Technical Note

Project: East Shilton, Leicestershire

Subject: East Shilton Section 278 works

Client:	Vistry		
Project No:	09924	Version:	A
Document Ref:	TN001	Author:	Richard Ellam
Date:	23/12/2025	Approved:	Richard Ellam

Figure 4: Proposed site's accommodation of Hill Top Farm junction

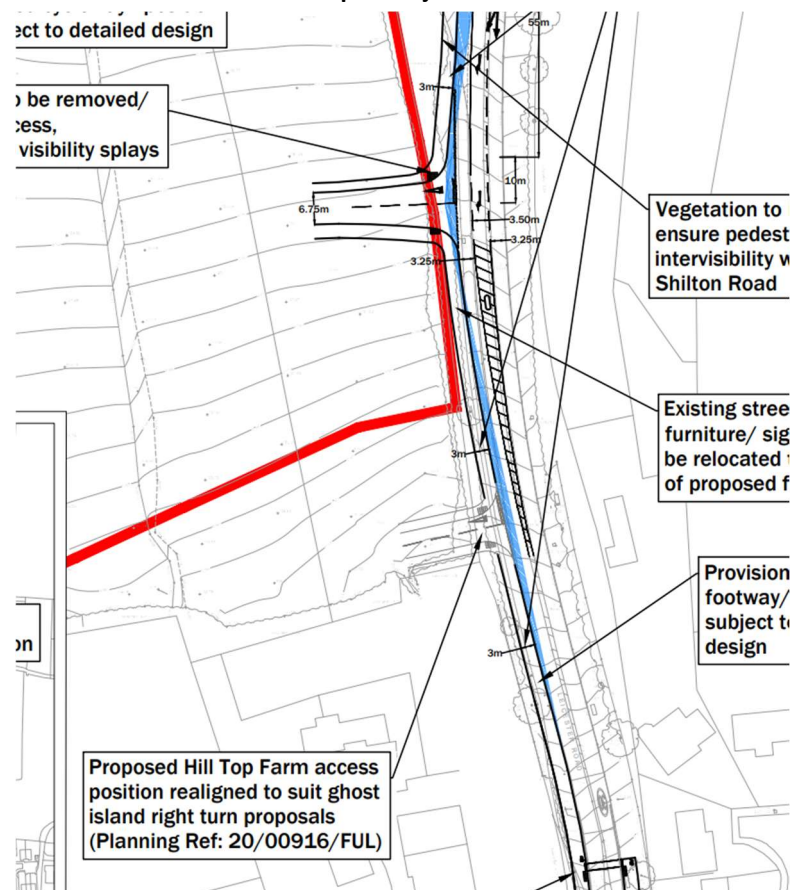
- 3.1.4 The Hill Top Farm priority junction is modest and in the form of a simple priority and as such doesn't affect the highway network to the north of the proposed junctions' location. Indeed, the extent of the works is shown in green on Figure and extents approximately 2m north of the corner radii of the proposed junction.
- 3.1.5 Figure shows how the proposed site has referenced and accommodated the Ashby House junction in presenting its access strategy. As can be seen the proposal involves realigning the Hill Top Farm access to facilitate the Ghost Island Right Turn proposals.

- 3.1.6 In design terms, the Hill Top Farm access had been realigned very slightly into that site, in a westward direction, to ensure the visibility splays (2.4m by 120m) from the proposed site's access, shown in blue on Figure , could be accommodated without infringement from the Hill Top Farm access.
- 3.1.7 Leicester Road is currently subject to a 50mph speed limit along both site frontages, which has results in the fairly onerous visibility splay requirements to match the speed of the road.

Figure 5: Proposed revised access arrangement

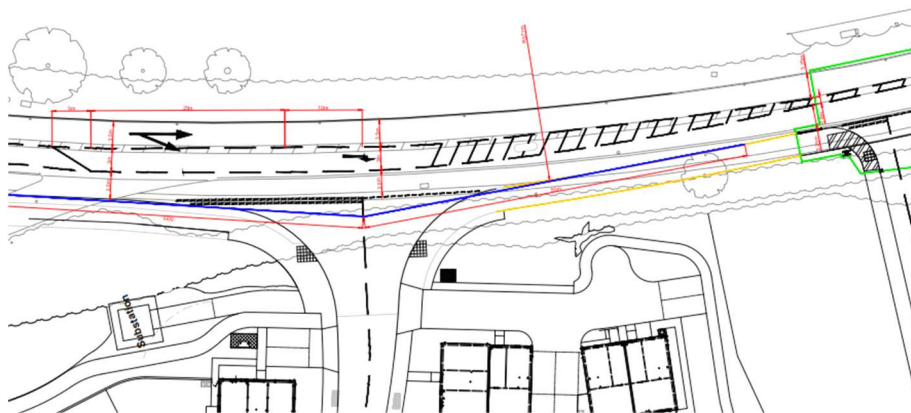
- The **30mph speed limit commencement be moved further north** to the north of the junction with Shilton Road.
- The speed limit is thus reduced along the site frontage of both sites to 30mph.
- The resultant visibility requirements are reduced accordingly and can now be accommodated without the need to move the Hill Top access slightly to the west.

- The Hill Top S278 detailed design, shown in green, is not affected by the proposed sites works.
- The Ghost Island right turn lane is maintained but the dimensions are reduced to reflect the 30mph speed limit.
- The works to the proposed sites minor arm remain as developed to date and incorporate the comments received from LCC.
- The other proposed offsite works to the north of the access point **all remain the same** as proposed and refined to date in the S278 process.

- Reduced visibility splays of 2.4m by 50m.
- 3m wide right turn lane.
- Right turn lane geometry in accordance with CD123 and a 30mph design speed.
- Tapers to tie into the central hatching before the Hill Top Farm access extents, in accordance with CD123.

X	Drawing Number:	Revision:
	10015653-ARC-XX-XX-SK-C-0002	P01

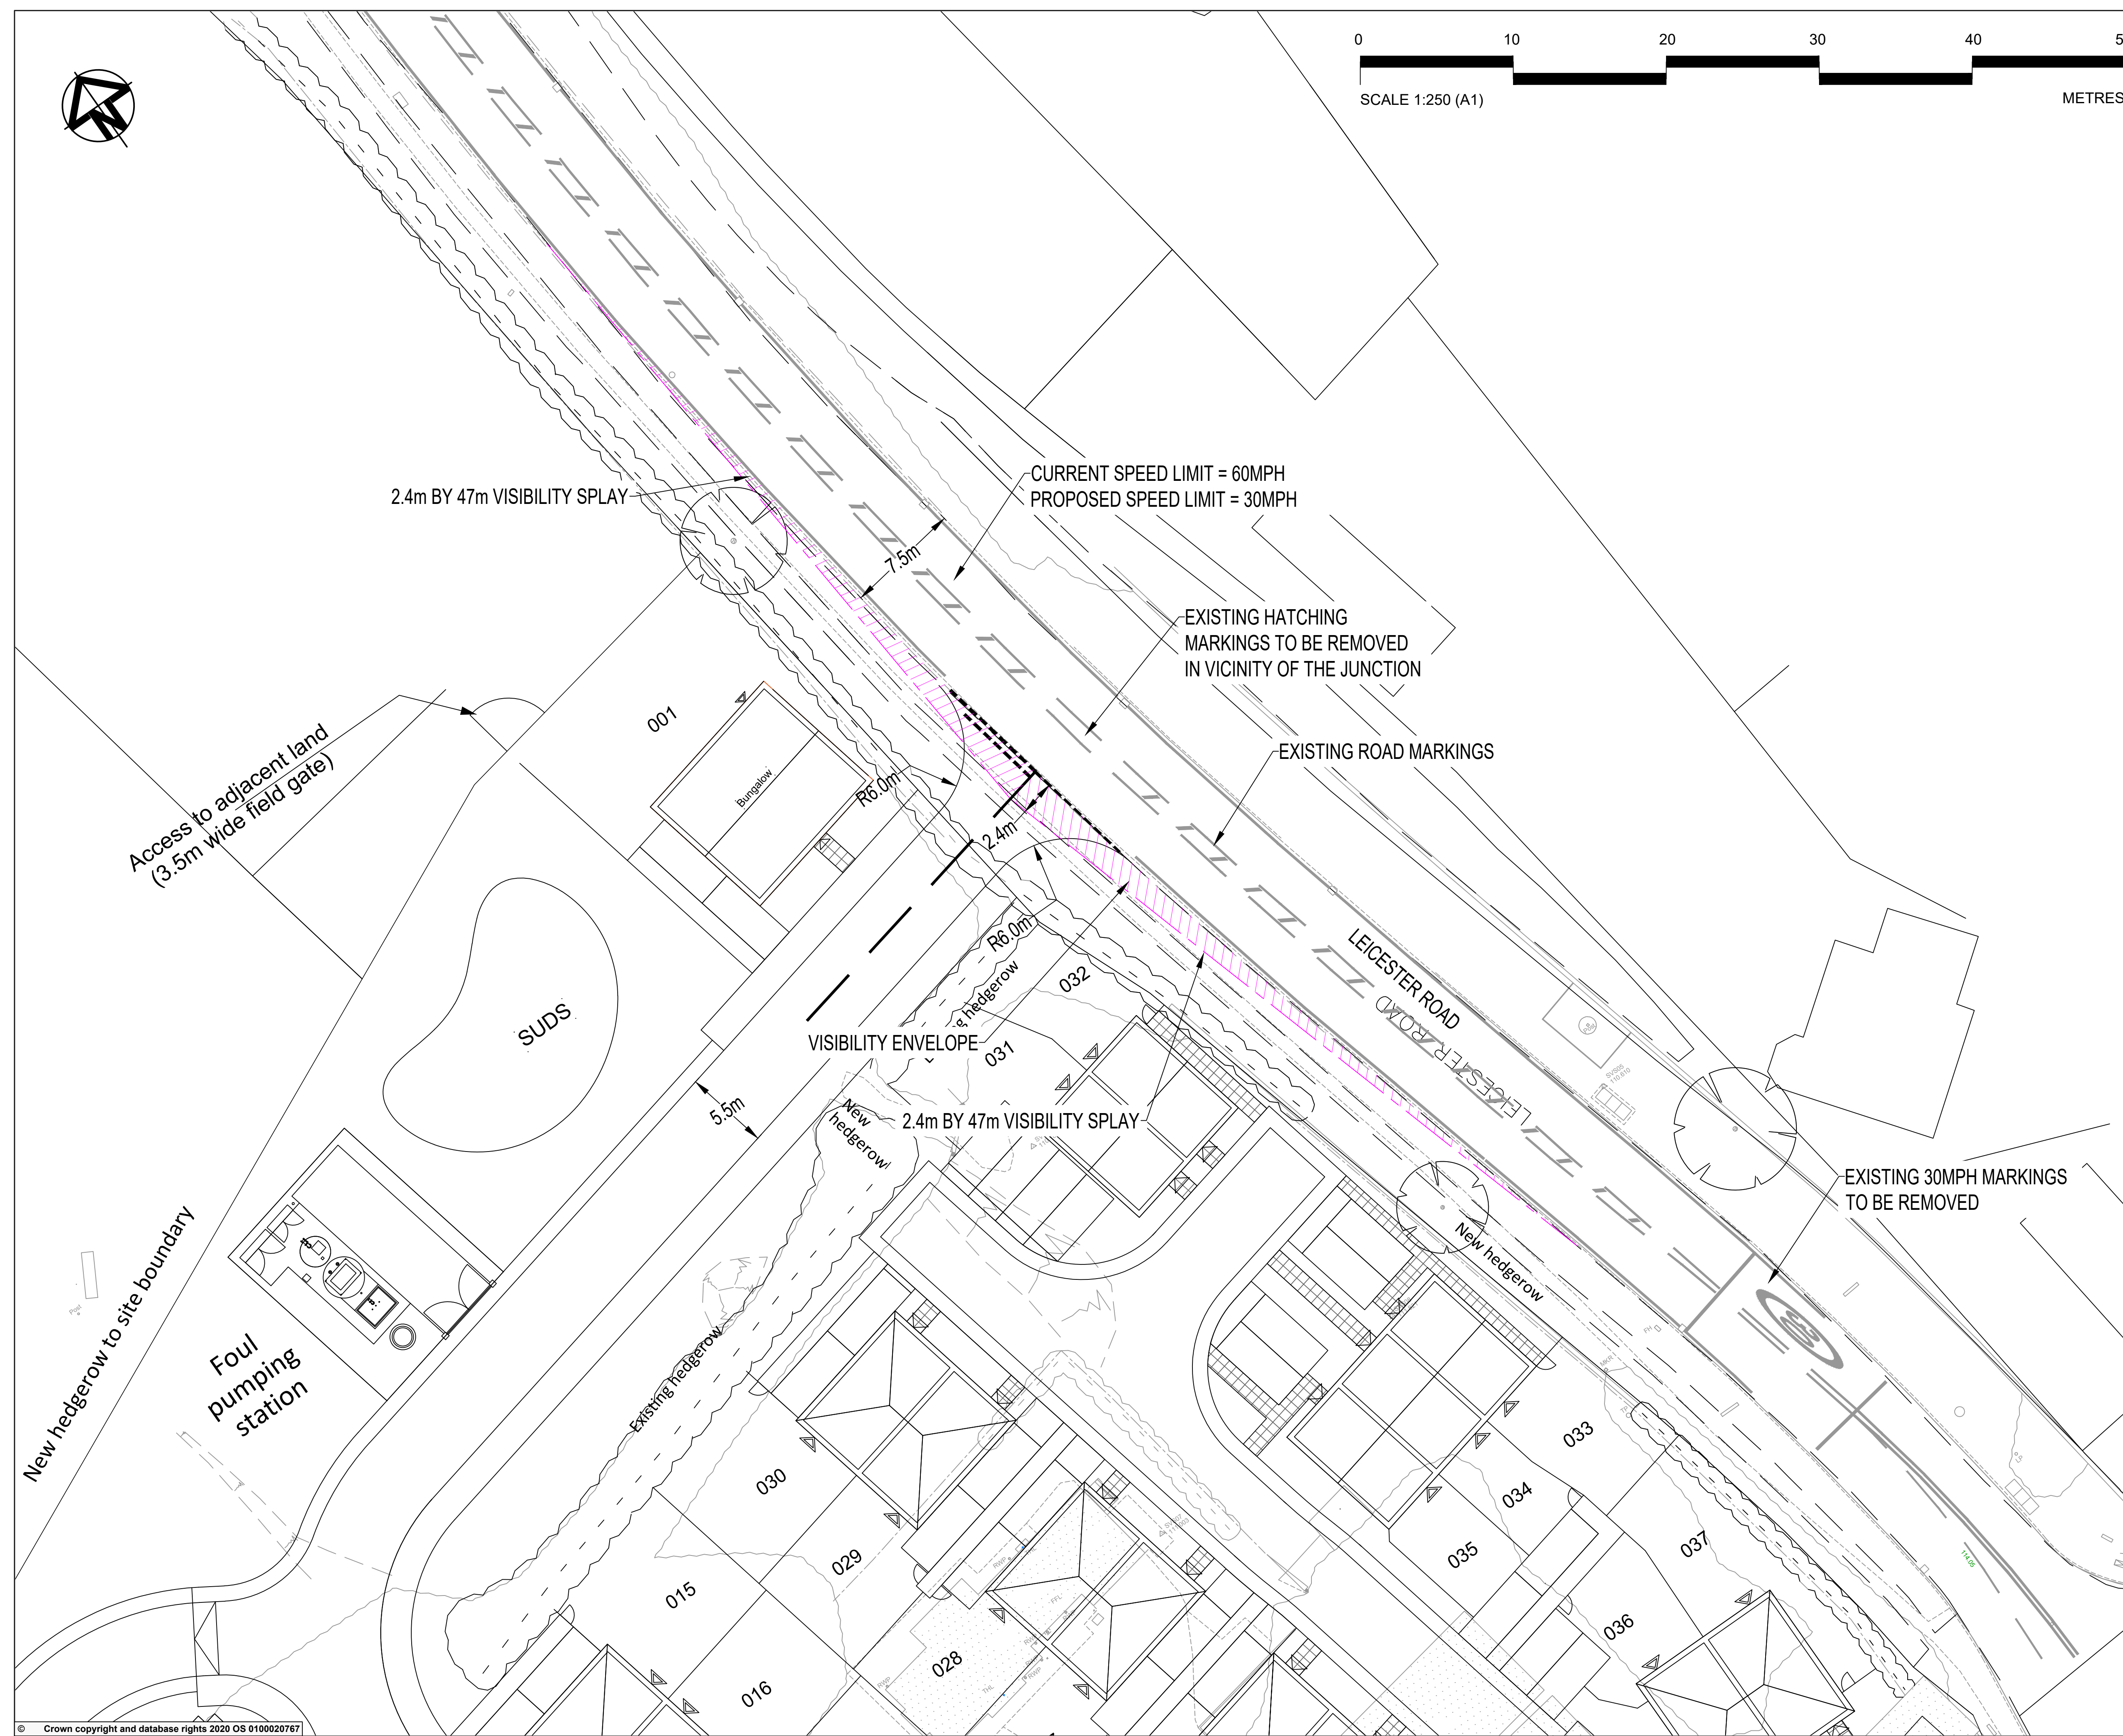
Location: A - Proposed site access (Drawing Number 10015653-ARC-XX-XX-SK-C-0002 Rev P03).

Summary: Insufficient forward visibility relative to speed of vehicles may lead to an increased risk of collision.

The new site access proposed on the western side of Leicester Road is to be located following a left-hand bend in the road alignment for both the northbound and southbound approaches. Southbound, the alignment appears more relaxed, with visibility partially restricted by vegetation adjacent to the nearside kerb line. However, on the northbound approach visibility appears more restricted due to a tighter kerb radius, vegetation and a building adjacent to the western footway.

The speed limit is proposed to be reduced to 30mph at the proposed access, which will increase to 50mph approximately 25m to the north of this location.

The Audit Team is concerned that this change in speed limit is too close to the proposed access, which may lead to motorists on approach to the access travelling too fast for conditions and with insufficient forward visibility. This may lead to an increased risk of motorists exiting the proposed access into the path of northbound vehicles, resulting in a collision.

Similarly, although visibility appears better between the access and traffic in the southbound direction, the Audit Team is unaware of any landscape proposals or potential site clearance. Should vegetation on the eastern side of Leicester Road unduly affect forward visibility on approach to the access, this may lead to an increased risk of vehicles waiting to turn right into the access being shunted from behind.

Ensure that forward visibility between the proposed access and main road traffic is sufficient for the speed of vehicles. This may involve relocating the transition between 30mph and 50mph speed limits some distance further north, away from the proposed access junction. It may also be beneficial to provide some form of speed control measures, e.g. roundels, signage, speed cushions or similar, particularly to the south of the site access.

In addition, it should be ensured that vegetation is cut back and maintained to provide sufficient forward visibility.
